**Request for Additional Information – Siemens Power Corporation Topical Reports,  
EMF-2310(P) Revision 0, (TAC No. MA7192) and EMF-2328(P) Revision 0, (TAC No. MA8022)**

## S-RELAP5 Request for Additional Information (RAI)

*The following are in regard to EMF-2100(P) Rev. 2:*

**Figure 1. Comparison of energy error between S-RELAP5 and RELAP5/MOD2 energy equations**

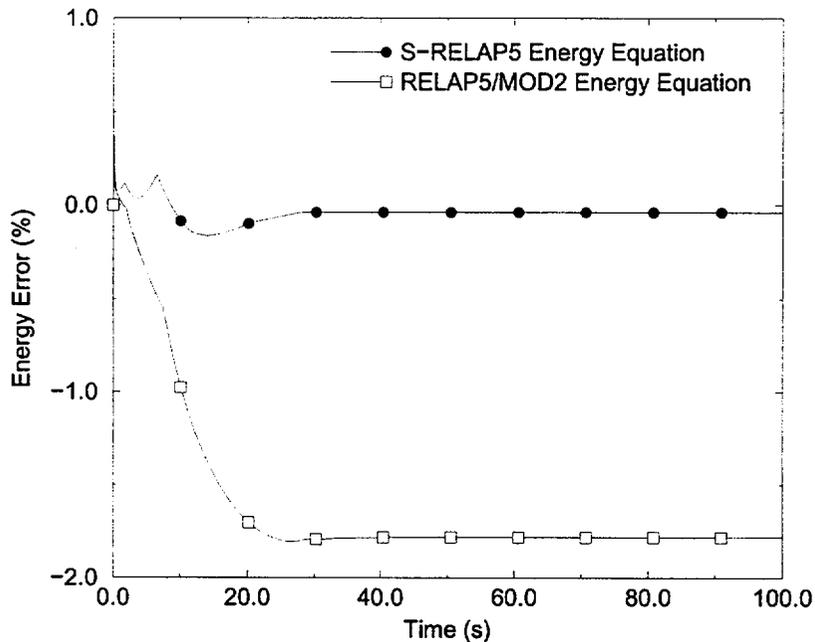
2.6 *On Page 2-6 you stated that under most circumstances, assessment calculations indicate that there are essentially no differences in the results of key loss of coolant accident (LOCA) parameters between the RELAP5/MOD2 energy equations and the energy equations provided in S-RELAP5. Please provide a discussion of the assessment calculations performed including a discussion of the key LOCA parameters that were assessed. In addition, please provide a discussion of the circumstances where differences were identified and justify your methodology in light of those differences. Also, provide similar discussions related to the other transients that you are proposing to analyze with the code.*

A demonstration calculation can be made to show the energy error when using the S-RELAP5 energy equations compared to the RELAP5/MOD2 energy equations. Consider a closed system where potential and kinetic energies are negligible and consisting of a small diameter pipe (1 m) at high pressure (150 bar) blowing down into a large diameter pipe (10 m) at low pressure ( 1 bar) through an orifice. Since there is no change in total internal energy in a perfect system, a comparison of initial internal energy to the transient internal energy during the blowdown should indicate net internal energy error.

A calculation of this type was made with both S-RELAP5 and ANF-RELAP (ANF-RELAP uses RELAP5/MOD2 energy equations). The results in Figure 1 show that energy is conserved to within 0.04% by S-RELAP5 while ANF-RELAP shows an error of approximately -2%. These results imply that there will be a much smaller energy error when transferring energy out of a system (i.e., coupled primary and containment calculation) using S-RELAP5 compared to a code using the RELAP5/MOD2 energy equations.
